Access Compliance Report

Public Rights-of-Way

(Curb Ramps)

Intersection ID: 31624	Main Street: BRADFORD_DR	Cross Street: THOMASBORO_DR	Location: NW
ADA ID: DDD9C5F09BA	Ramp Type: Perp	Initial Pass/Fail: Fail	Overall Compliance: No
			Severity Score: 22.5

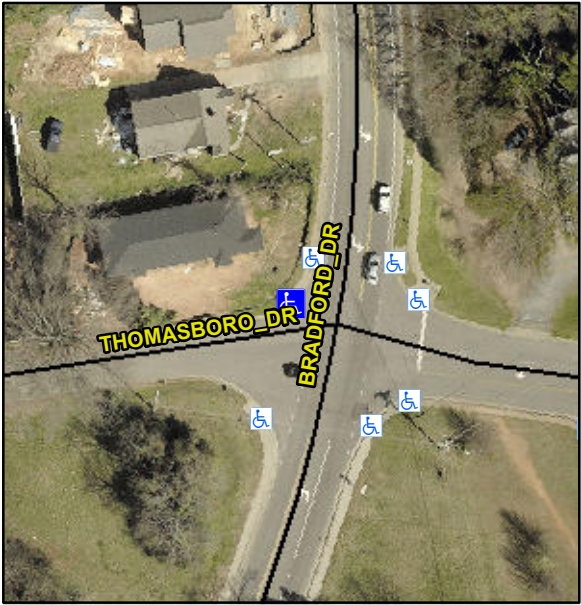
Codes/Mitigation Info/Possible Solution			Field Measurements/Component Compliance		
	Possible Solutions:		Compliance	Description	Data
	Remove & Replace Entire Ramp.		No	Ramp Length (in)	59.0
			No	Ramp Width (in)	40.0
			N/A	Flare Type LT	N/A
			N/A	Flare Slope LT (%)	N/A
			N/A	Flare Traversable LT?	N/A
			N/A	Landing Length (in)	N/A
			N/A	Landing Width (in)	N/A
			N/A	Landing Slope (%)	N/A
			N/A	Landing X Slope (%)	N/A
Surveyor Notes: N/A PROW/ADA: R304.5.1, R304.2.2, R304.5.3			N/A	Flare Type RT	N/A
			N/A	Flare Slope RT (%)	N/A
			N/A	Flare Traversable RT?	N/A
			N/A	DWS Provided?	N/A
			N/A	DWS Contrast?	N/A
			N/A	DWS Length (in)	N/A
			N/A	DWS Full Width?	N/A
			N/A	DWS Offset (in)	N/A
			N/A	Shared Landing?	N/A
			N/A	Gutter Ponding?	N/A
			N/A	Gutter Lip Ht (in)	N/A
			No	Painted X Walk1?	N/A
			To S	X Walk 1 Direction	N/A
			N/A	X Walk 1 Width (in)	N/A

2.4	X Walk 1 Slope (%)	N/A
			0.8	X Walk 1 X Slope (%)	N/A
			N/A	Ramp inside XWalk1?	N/A
			N/A	Road Slope (%)	N/A
			N/A	Road X Slope (%)	N/A
			N/A	Any Obstructions?	N/A
			N/A	Obstruction Type	N/A
			N/A	Clear Space?	N/A
			N/A	Clear Space to XWalk (in)	N/A
			N/A	Storm Grate/Utility Hazard?	N/A
			N/A	Storm Grate/Utility Type	N/A
			N/A	Surface Condition? (G/P)	Good
Total Cost:		\$ 1850.00
